GREENVIEW HOTEL

Issue: Vertical accessibility to various levels in the building and size of existing elevator.

**REQUEST FOR WAIVER FROM ACCESSIBILITY REQUIREMENTS
OF CHAPTER 553, PART V, FLORIDA STATUTES**

2 AS-BUILT FIRST FLOOR PLAN

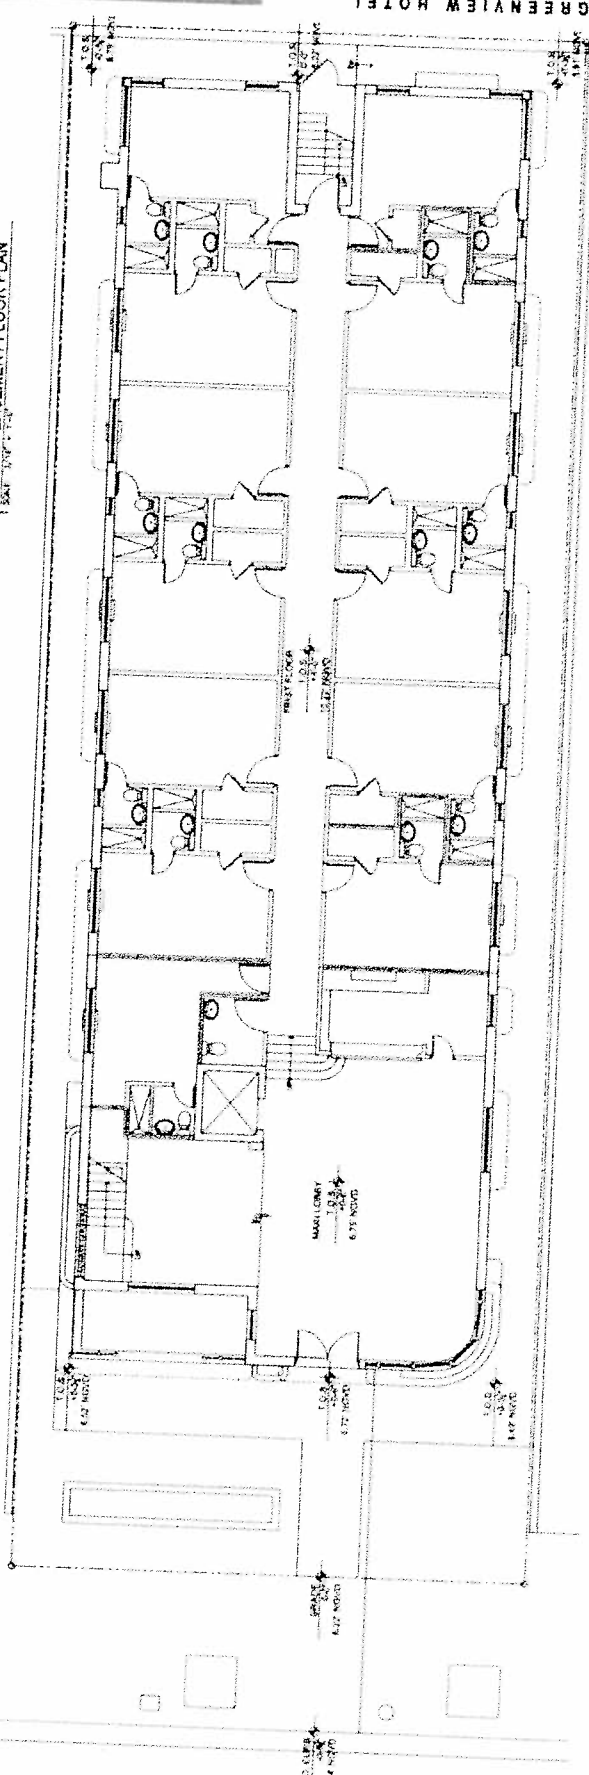
The hotel has an elevated first guest room floor that is not, and cannot be, served by the elevator. Because of the width of the steps from the lobby entrance level to the first floor's nominal 60" wide (58-1/2" actual) corridor, an inclined lift may not be used to provide vertical accessibility as it would encroach the required means of egress.

The stair from the lobby to the first floor guest rooms level narrows to 58-1/2 at the top, the finished width of the corridor. The stair is sandwiched between the elevator on one side and the historic front desk (which must be preserved) on the other. This would allow only a wheelchair stair lift (such as a Garaventa lift) to be used. However, because of the width of the stair and encroachment of the lift, the lift would encroach the required means of egress and would not be approved by the fire marshal. For that reason, we feel that providing a lift to the first elevated level would be technically infeasible.
